Deleted: 1
Deleted: October
Deleted: 3
Inserted: October 23, 2001

Emergency Preparedness
Significance Determination Process

Sheet 2

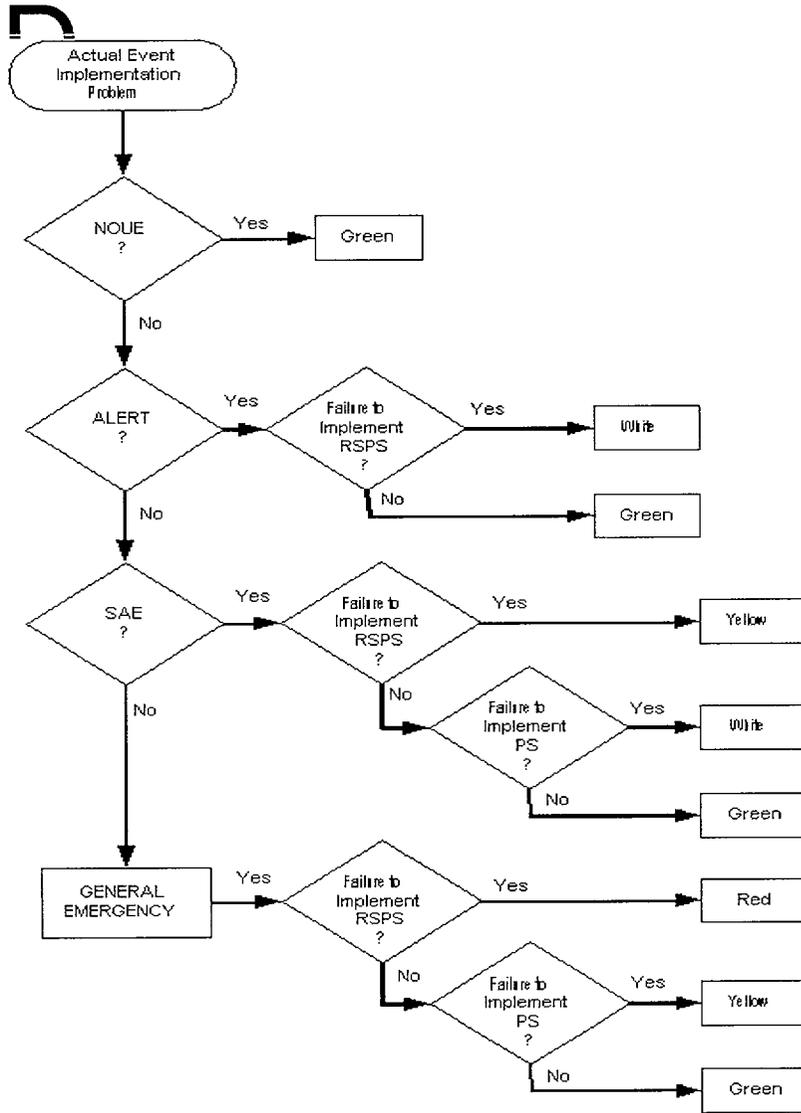
Proposed Revision to EP SDP
Failure to meet Regulatory Requirement
(This line replaces left line sheet 1 Failure to meet Regulatory Requirement)
